**Re: #PLUS 2007-12-01; Batson Creek Estates  
Tax Parcel No. 5-33-11.00-84.00**

Enclosed for your review and consideration please find one (1) copy of a revised Preliminary Subdivision Plan for the above referenced site, attached in PDF format and our response to the PLUS review (#2007-12-01).

RE: PLUS review – 2007-12-01; Batson Creek Estates

# PRELIMINARY SUBDIVISION PLAN AR-1 CLUSTER DEVELOPMENT OPTION FOR PROPERTY KNOWN AS: **BATSON CREEK ESTATES**

SUBDIVISION STREET  
\* LOT Nos. 34-48 & 51-54 SHALL BE REQUIRED TO HAVE A REAR YARD SETBACK OF TWENTY FEET.  
**BUILDING SETBACK DETAIL**  
(SCALE: 1" = 50')

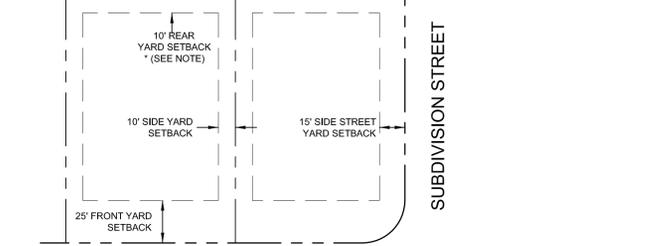
- An increase of the side yard setback to 15 feet may be needed on all properties with a drainage easement on the side. The increase will allow room for equipment to utilize the entire easement and maneuver free of obstructions if the drainage conveyance requires periodic maintenance or future re-construction. The side yard setback would only increase on the side with the drainage

easement. *{If it is determined that drainage easements will be required on side lot lines, the side yards adjacent to those easements will have a fifteen (15) foot side yard setback which will be graphically depicted and recorded on the final record plan.}*

**PRELIMINARY SUBDIVISION PLAN**  
 FOR PROPERTY KNOWN AS:  
**BATSON CREEK ESTATES**  
 PREPARED FOR:  
**MATTHEW BRITTINGHAM**  
 SITUATE IN:  
 BALTIMORE HUNDRED \* SUSSEX COUNTY  
 STATE OF DELAWARE  
 TAX PARCEL #: 5-33-11.00-84.00  
 SCALE: 1" = 100'

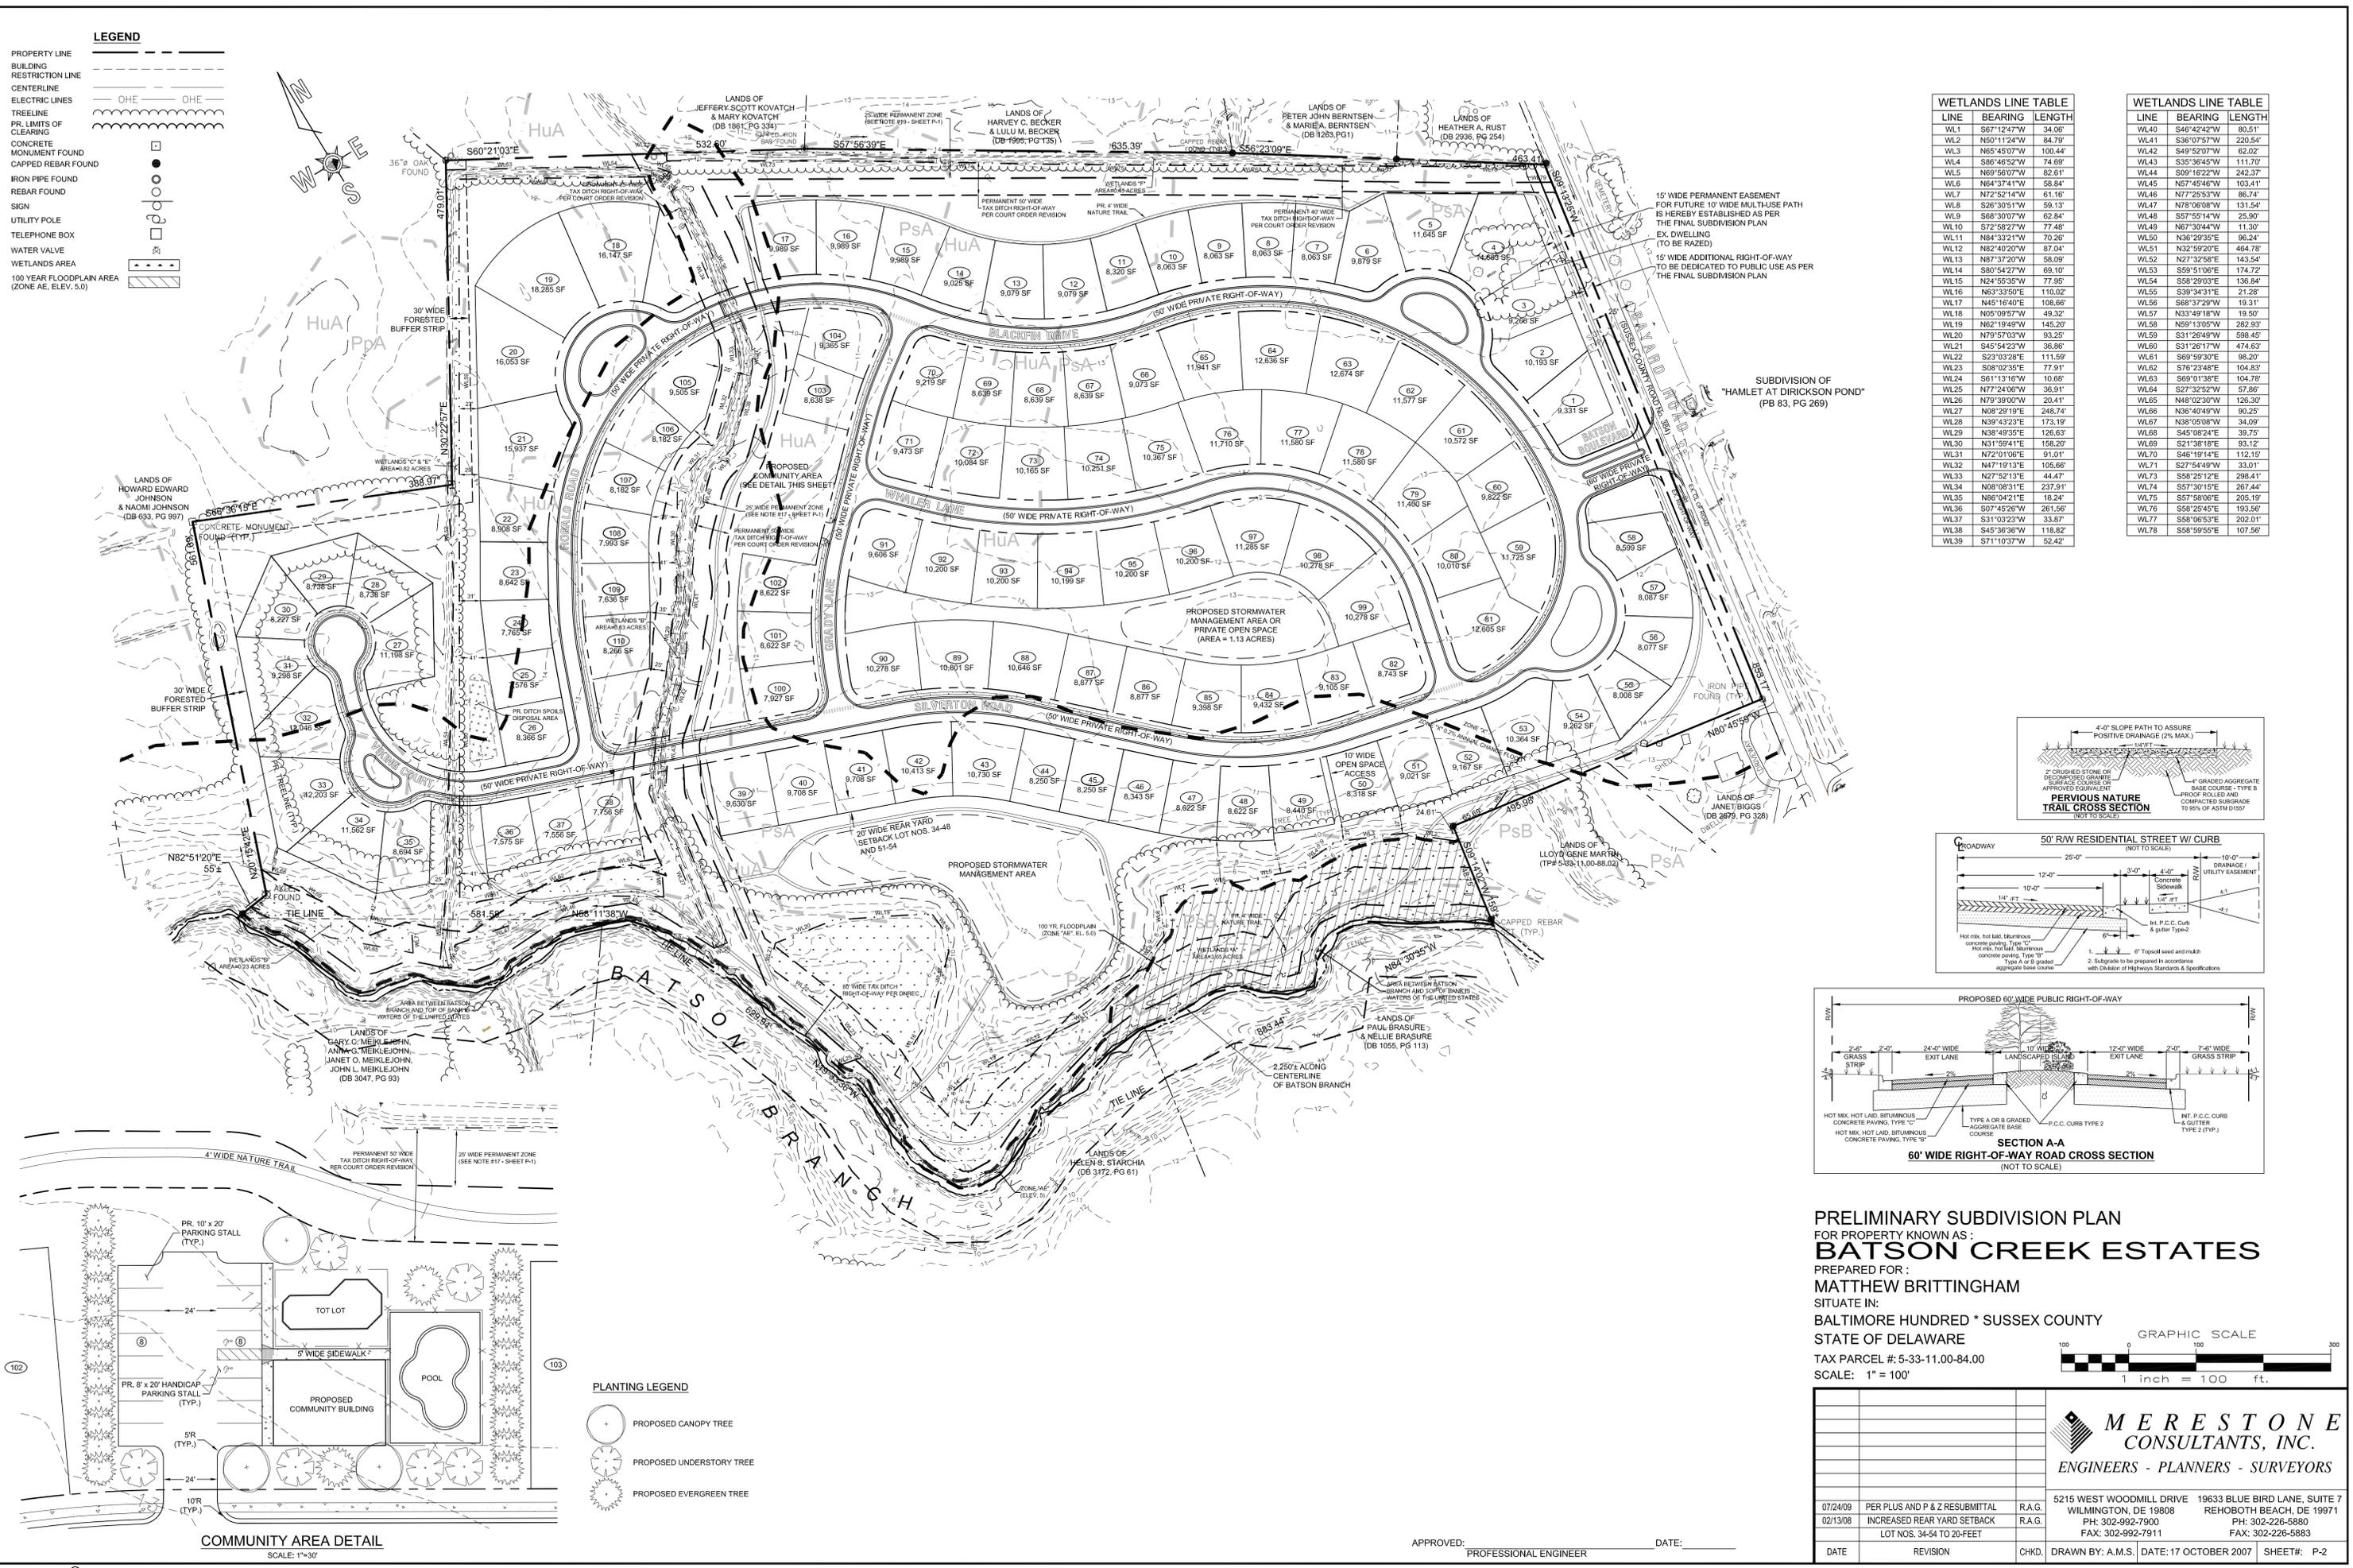
Based on a review of existing buffer research by Castelle et al. (1994), an adequately-sized buffer that effectively protects wetlands and streams, in most circumstances, is about 100-foot in width. In recognition of this research and the need to protect water quality, the Watershed Assessment Section recommends that the applicant maintain/establish a minimum 100-foot upland buffer (planted in native vegetation) from the landward edge of all wetlands and water bodies (including all ditches). *The plan proposes to protect the wetland areas with no forest removal proposed for stormwater purposes. No wetlands exist within any lot boundaries and with lots 34-53 required to have a twenty-foot rear yard setback no houses or structures, with the exception of lots 49 & 50, could be erected nearer than 50-feet to these wetlands. In fact, a majority of the structure setbacks from these wetlands will be more than 100-feet. The depths of lots 19-23, 49 & 50 have been reduced to increase the upland buffer to a minimum of 25-feet.*

We appreciate the fact that both the 1% and 0.2% chance flood elevations are shown on the site plan. However, the 1% elevation is very hard to follow. It appears that all the lots would be located outside the 1% chance flood area (100 year floodplain). Is the detention pond located outside the 1% chance flood area? It is recommended that none of these homes have basements as quit a few of them are located in the 0.2% chance flood area (500 year floodplain). *{The plan has been revised to more clearly show the 1% and 0.2% chance flood elevations. All lots and the stormwater management facility will be located outside of the 1% chance flood elevation. Basements will be allowed subject to the appropriate soils and geotechnical testing that will support their installation.}*

- Consider future maintenance needs for the private ditch on the western side of the property. Establish a spoil disposal area within the open space to the rear of lots 22-26 and note on the record plan. Adjust the rear lot lines of lots 22 and 23 to allow for 25 feet between the top of the ditch bank and the lot line. *{The plan has been revised to include a spoils disposal area behind lots 25 & 26. The depths of lots 19-23, 49 & 50 have been reduced to increase the upland buffer to a minimum of 25-feet from their respective lot lines.}*

1. In the interest of water quality and to protect rare species, there should be at least a 100-foot upland buffer left intact along Batson Branch and associated wetlands. The application states that only 25-foot buffers will be left between lot lines and wetlands. This is highly inadequate from a scientific standpoint. We recommend that lots within 100 feet of wetlands be pulled back or omitted from the plan. Cumulative impacts to water quality are a real concern considering the level of development (existing, in-progress, and future) along this water system. *{The plan proposes no disturbance to these wetland areas other than roadway crossings necessary to provide access to proposed lots. The wetland area adjacent to Batson Branch appears to be a more significant palustrine forested riparian wetlands area which continues offsite. The plan proposes to protect this area with no forest removal proposed for stormwater or infra-structure purposes to this area. No wetlands exist within any lot boundaries and with lots 34-48 & 51-53 required to have a twenty-foot rear yard setback no houses or structures, with the exception of lots 49 & 50, could be erected nearer than 50-feet to these wetlands. In fact, a majority of the structure setbacks from these wetlands will be more than 100-feet.}*

- 1) DNREC recommends that lot #s 27-35 be omitted so that tree removal is minimal and a larger area of forest open space can remain for wildlife habitat and travel. *{The plan proposes the preservation of approximately 10.4 acres (83%) of forested lands. A minimal amount of forest removal will be required for the infra-structure improvements for lots 27-35. The plan provides for the protection of a significant existing forested riparian buffer adjacent to the wetland areas of Batson Branch in its entirety.}*

- *Approximately 2.2 acres (17%) will be removed for infra-structure improvements for lots 27-35 (this does not include those wooded areas within lots which may be protected from clearing through either deed restrictions or lot owner preference.*

- *There are only 9 wooded lots existing within the subdivision. The developer feels that this is a reasonable compromise considering the degree of protection given to the riparian buffer afforded to Batson Creek.}*
